Docket No. 272 - Development and Management Plan Inspection

The Connecticut Light and Power Company Certificate of Environmental Compatibility and Public Need for the construction of a new 345-kV electric transmission line and associated facilities between Scovill Rock Switching Station in Middletown and Norwalk Substation in Norwalk, Connecticut, including reconstruction of portions of existing 115-kV and 345-kV electric transmission line, the construction of Beseck Switching Station in Wallingford, East Devon Substation in Milford, (and Singer Substation in Bridgeport), modifications at Scovill Rock Switching Station and Norwalk Substation, and the reconfiguration of certain interconnections.

Segment 1a Inspection

Date: January 2, 2007

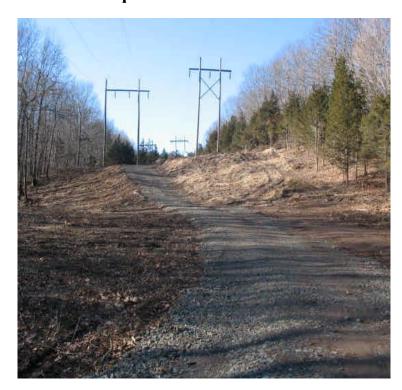
Riprap sediment trap and silt fence along the access road off Black Walnut Drive. Accumulated sediment should be removed and the silt fence repaired.

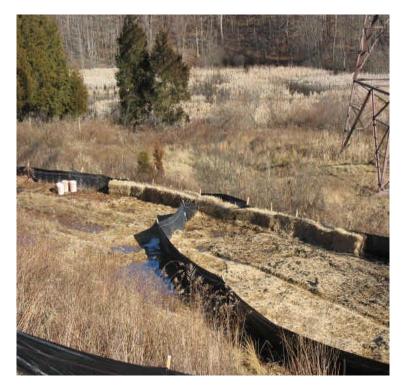
Turbidity in the pond adjacent to the contractor receiving yard has increased. A direct source is still being investigated.
